BEAVERDAM RUN DAM

FD-NO. PA. 805

PHASE I INSPECTION REPORT

Beaverdam Run Dam (PA 805), Ohio River
Basin, Beaverdam Run, Cambria County,
Pennsylvania. Phase I Inspection Report.

PLATE 5

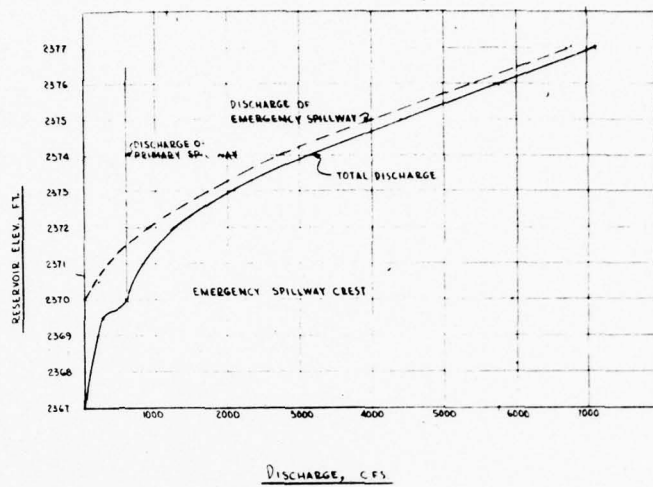
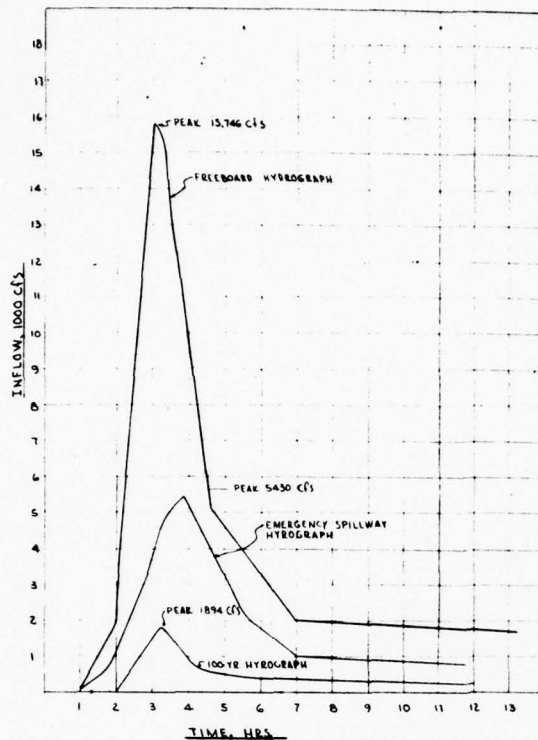
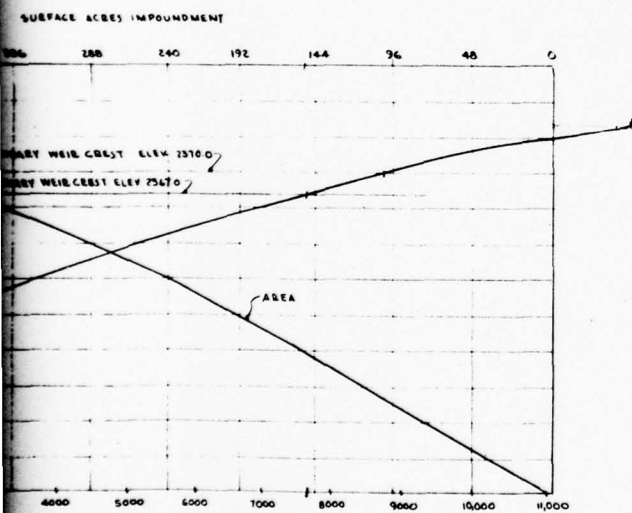
(1) Hydrology and Hydraulics. The reported results of the hydrology and hydraulic analyses indicate that the design followed currently accepted practices for such analyses. Area-capacity curves, spillway rating curves, inflow and outflow hydrographs are included in the design drawings (Plate 5).

BEAVERDAM RUN DAM
GENERAL PLAN
FIELD INSPECTION NOTES
FIELD INSPECTION DATE: MAY 15, 1978

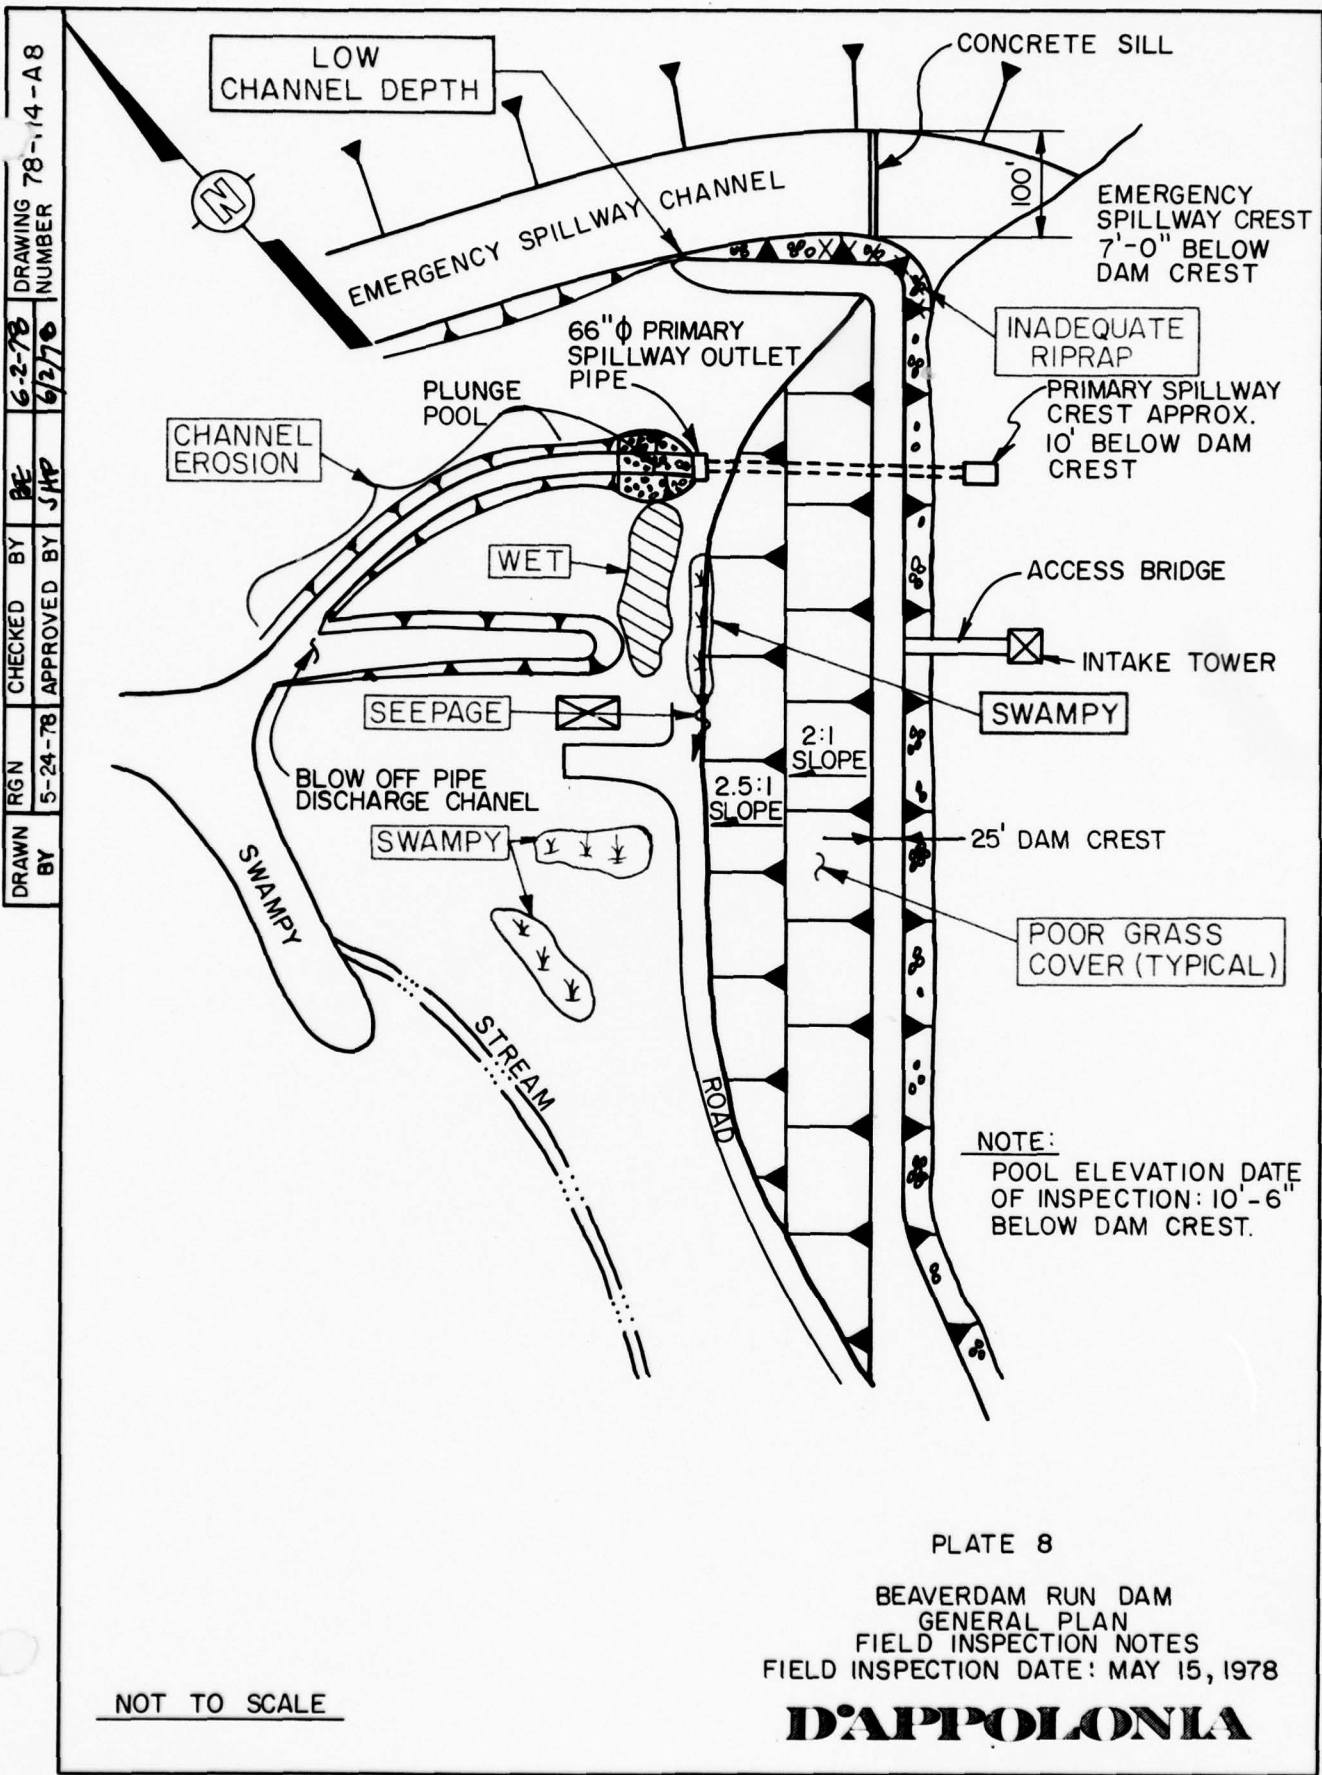
The specific observations are illustrated in Plate 8 and in the photographs in Appendix C.

1. Only one seepage area was observed. This was located to the left of the primary spillway along the toe. The total flow was estimated to be approximately 2 to 3 gallons per minute (gpm). The effect of this seepage on the overall performance of the dam is considered to be inconsequential at the present time, but it should continue to be monitored to assure that it is not increasing. The reservoir has probably not been filled long enough for steady-state seepage through the dam to have developed.
2. Approximately four isolated wet and swampy areas were found below the toe on the valley floor (Plate 8). No significant flow appeared to be discharging from these areas.
3. The grass cover on the downstream face of the dam was considered to be poor, requiring reseeding.

In general, the structures were found to be in good condition, with the exception of major erosion observed in the primary spillway discharge channel (Photograph 7) downstream from the plunge pool. This condition is not considered to be a safety hazard at its present extent. However, it should continue to be monitored to assure that it will not affect the performance of the plunge pool. The riprap at the emergency spillway entrance channel is inadequate to protect the embankment from erosion during high flows. Approximately 100 feet downstream from the crest, the left side of the emergency spillway channel is too low to contain major flows through the spillway. At flow depths of two to three feet over the spillway crest, it appears that the channel would overflow downslope toward the toe of the embankment.
